SECY-96-057

FOR: The Commissioners
FROM: James M. Taylor
Executive Director for Operations
SUBJECT: RELOCATION OF EMERGENCY OPERATIONS FACILITY FOR SUSQUEHANNA
STEAM ELECTRIC STATION

SUSQUEHANNA STEAM ELECTRIC STATION
PROPOSED REVISION TO THE EMERGENCY
PLAN: MOVING THE EOF TO THE NORTHEAST
DIVISION HEADQUARTERS
PLA-4298 FILE R41-2

FIGURE 8.3

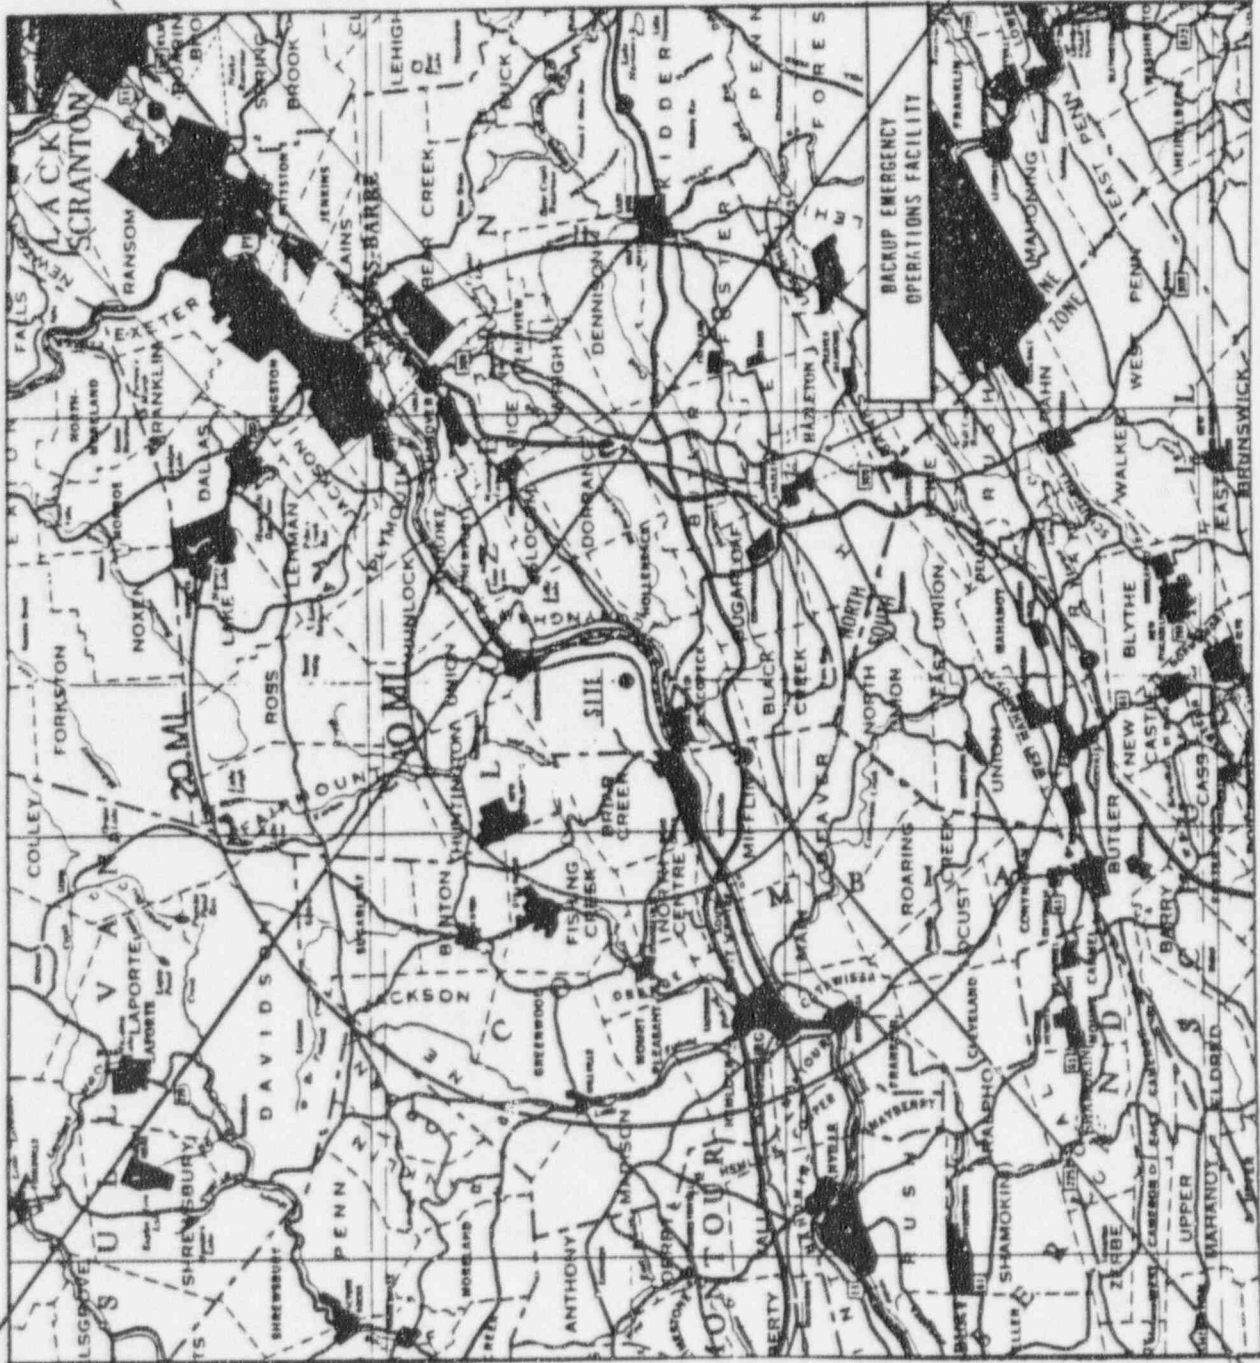
~~See Figure 8.3 for the spatial layout of the EOF.
The EOF is divided into three areas (Reference Figure 8.3):~~

- Insert 1 to Page 6-2 of the Emergency Plan has been revised to state that the EOF will be functional and take command within 90 minutes of the declaration of a Site Area Emergency. The revised insert is attached.
- The layout of the new EOF (Figure 8.3) has been revised and is attached.
